## Firmware 2.06.3 bug list:

## List of bugs/improvement requests

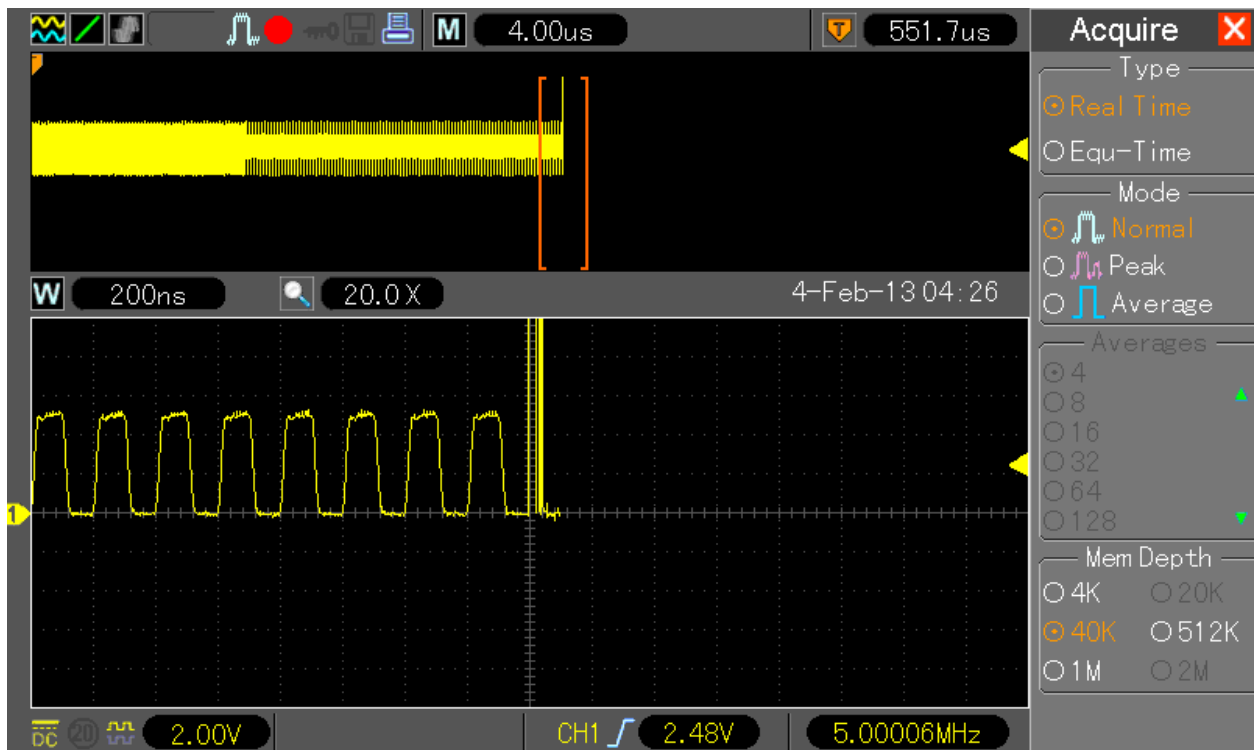
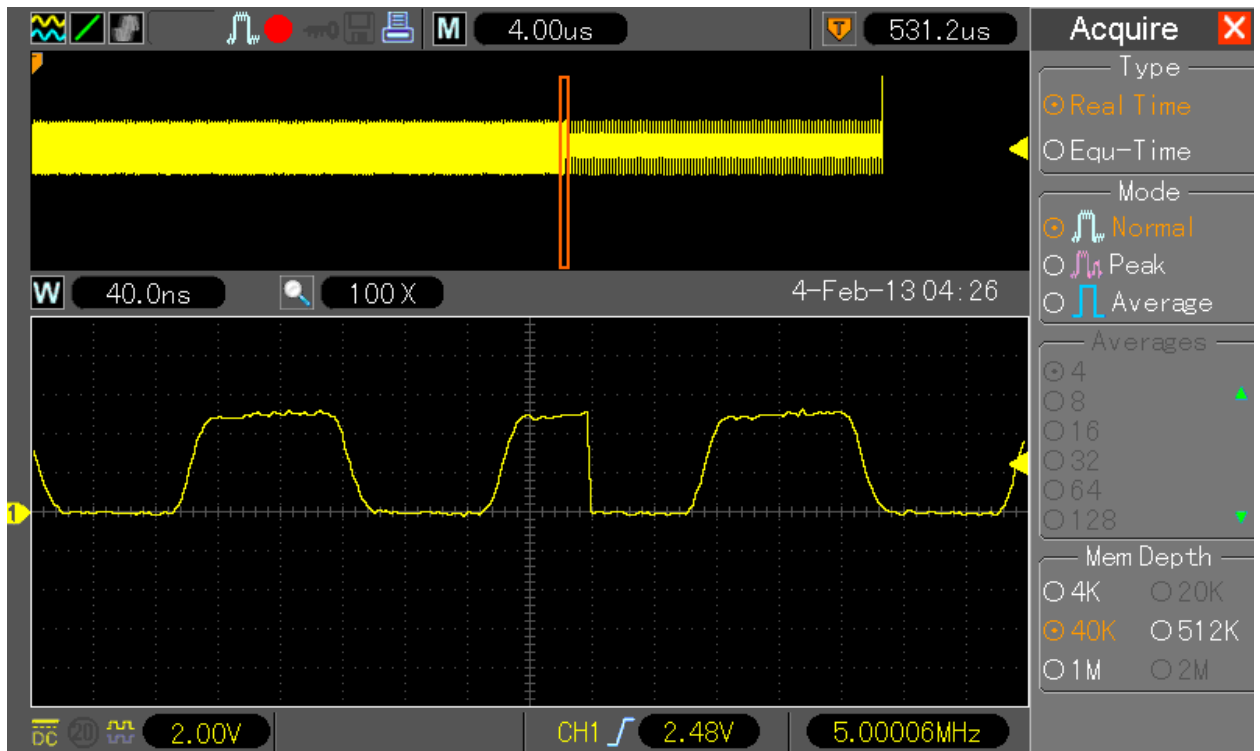
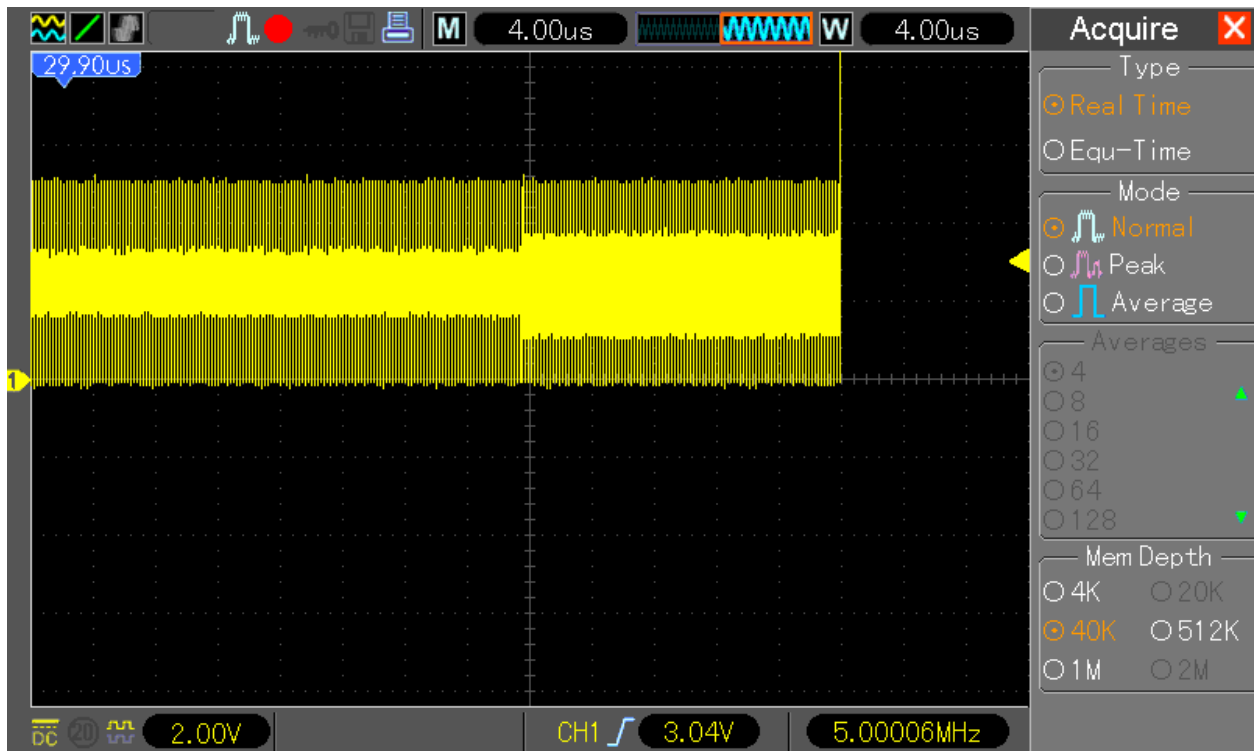
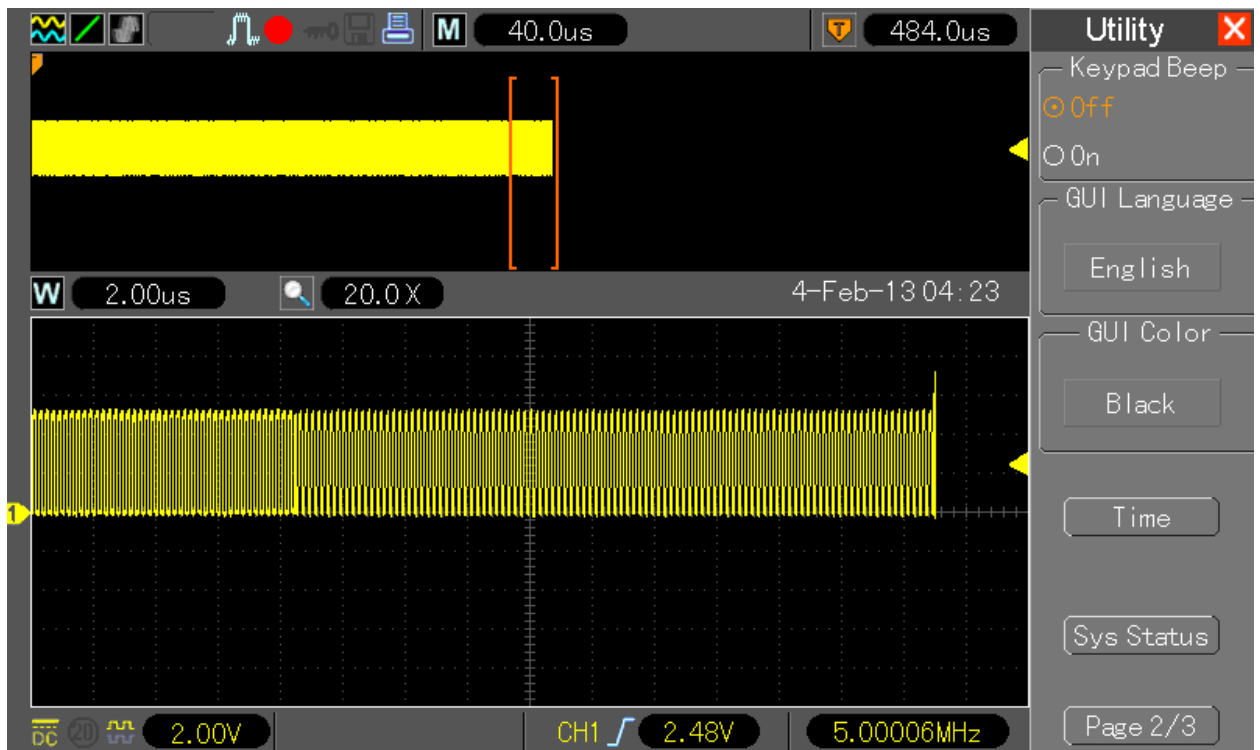
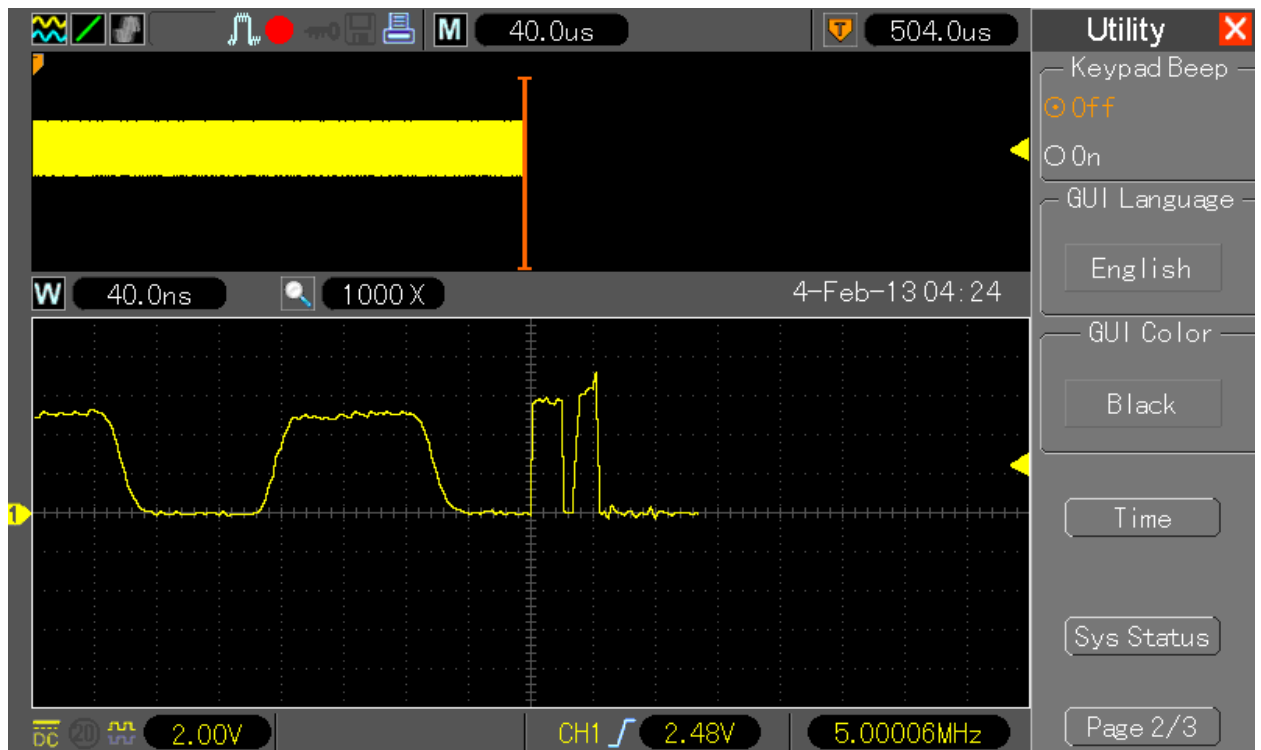
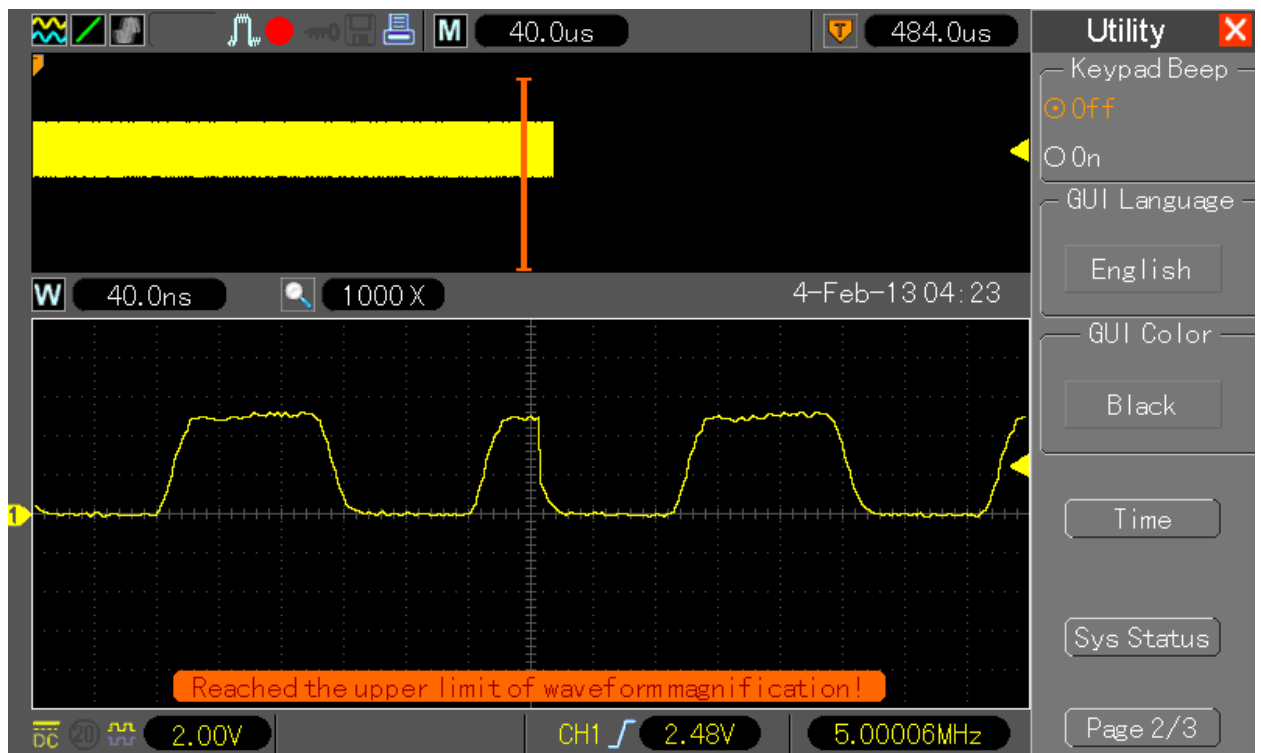
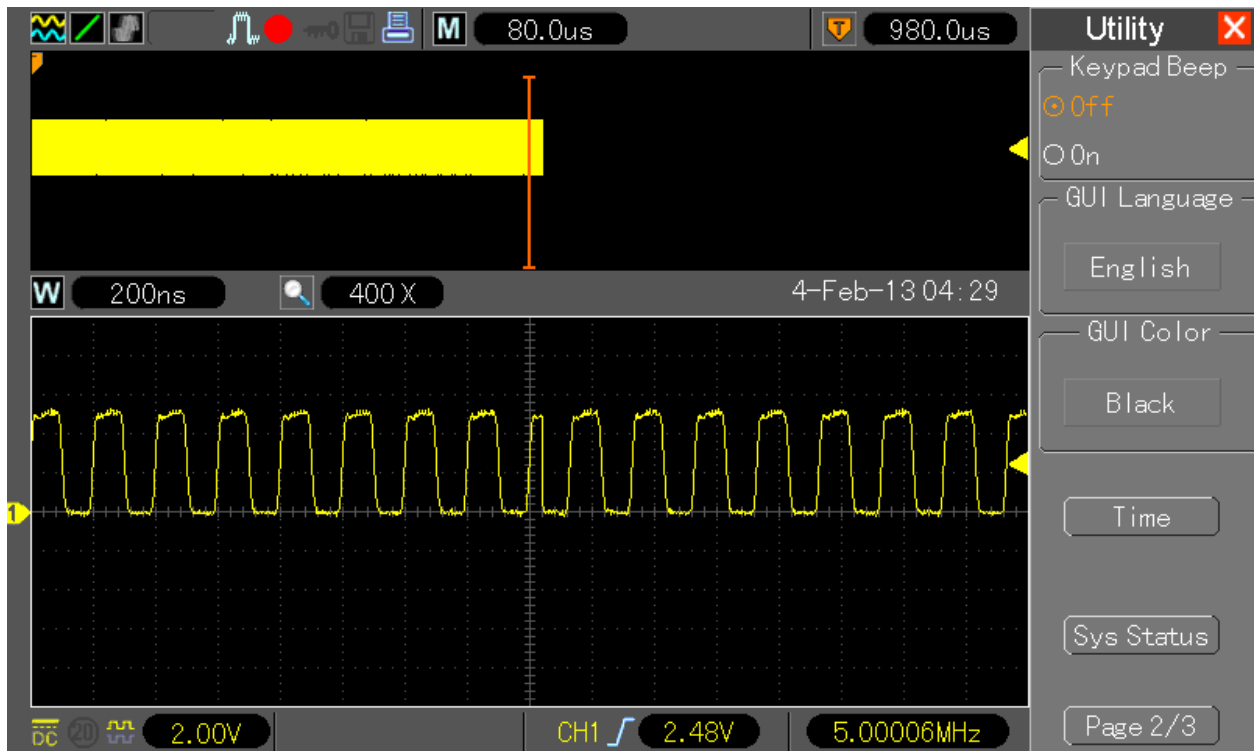
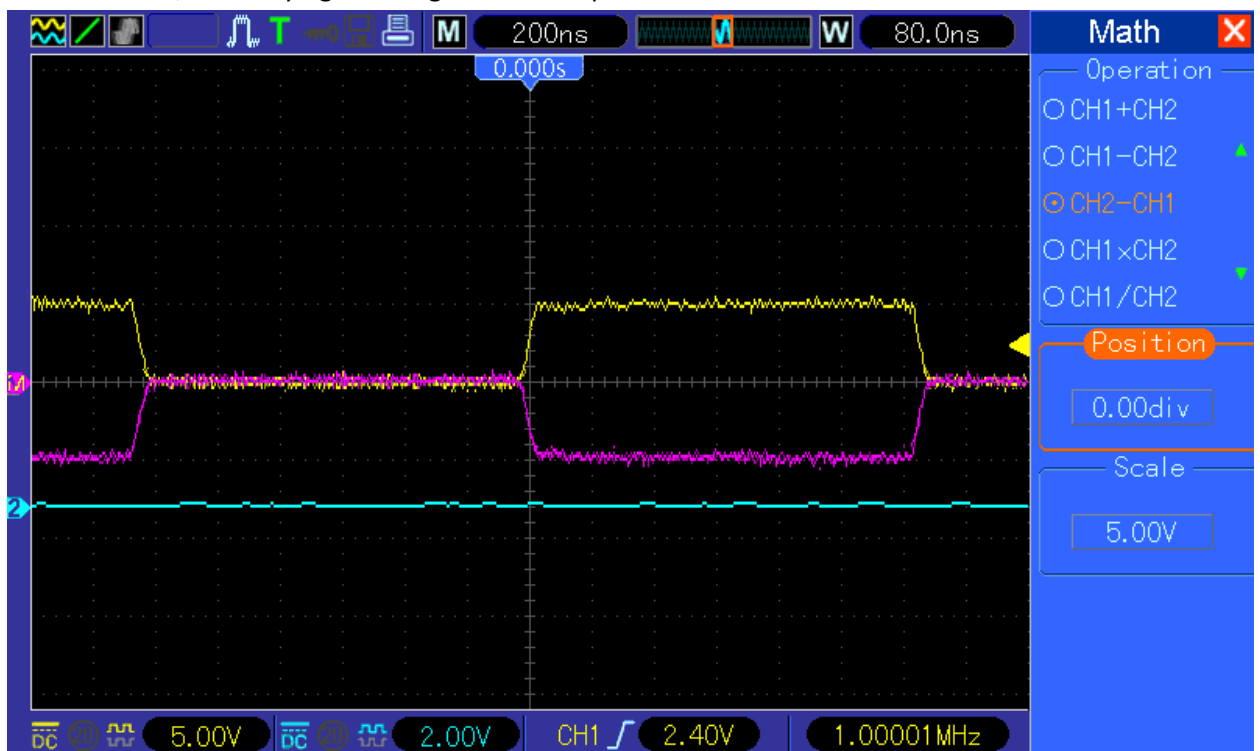
49. Artifacts on display when sampling with 400MS/s. Set 40k and 4us/DIV:

on the right part of the picture you can already see different waveform, when you move and zoom you see what's wrong:

Of course the same is visible in single window mode, so it does not have anything to do with window mode:

Same kind of error in 512k memory selection and 40us/DIV:

and as well in 1M and 80us/DIV:

It seems that no matter if the DSO is sampling with 200MS/s, 400MS/s or even 500MS/s (I played a bit deeper) the error is there in 40k, 512k and 1M always somewhere at the end of buffer (up to last ~ 3%).

- 39. Turn Timebase know one position forth and back, in most cases the Sampling Rate within FFT will be then updated to proper value.
- 40. ~~Ensure that no more than 10 file on the Flash Drive.~~
- 41. ~~No fix for this~~
- 42. ~~Nothing to say here.~~
- 43. ~~Nothing to say here.~~
- 44. ~~Nothing to say here.~~
- 45. ~~Nothing to say here.~~
- 46. ~~Nothing to say here.~~
- 47. When measuring waveform(s) use the tracking cursor only in main window. In wave/FFT mode it does works properly.
- 48. ~~Nothing to say here.~~
- 49. Simply ignore 5% of the right data/display region (when you look on display, the data near menu)

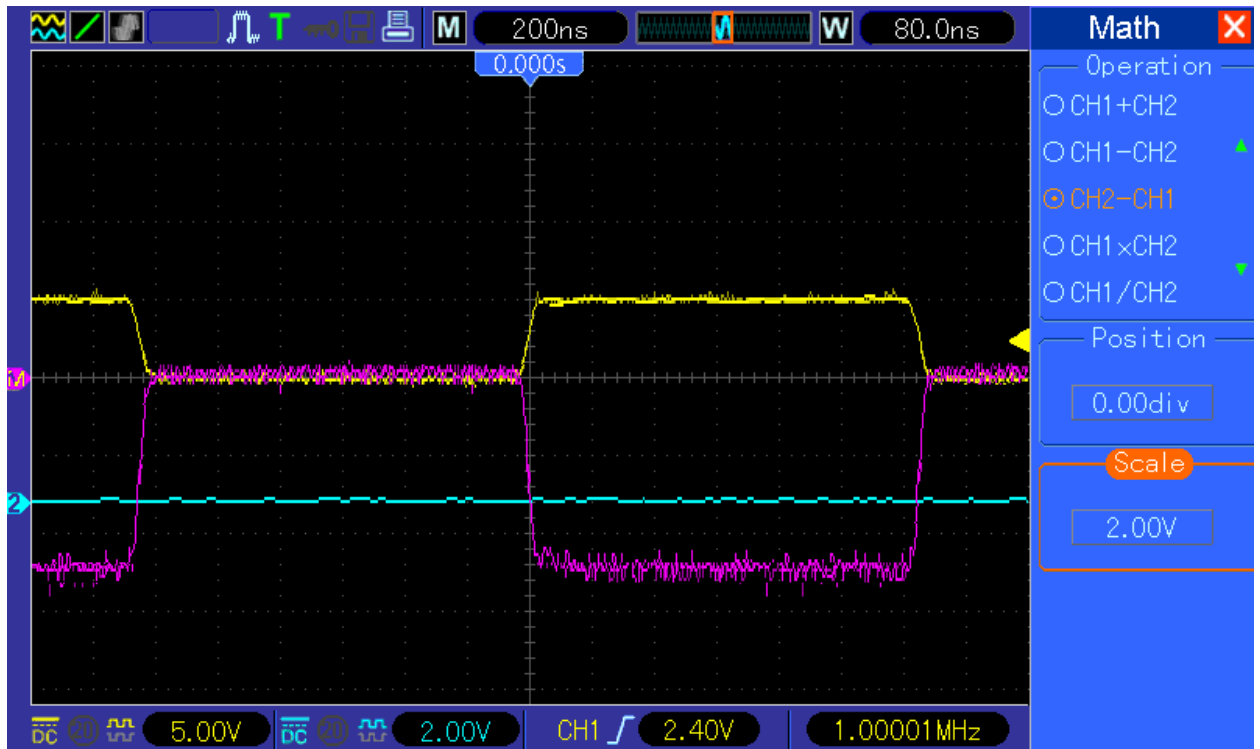
50. In Math menu, when trying to change waveform position with V0 knob:

the value of “Position” is not changing. Additionally the focus is jumping to “Scale” from “Position” and the value changing there:
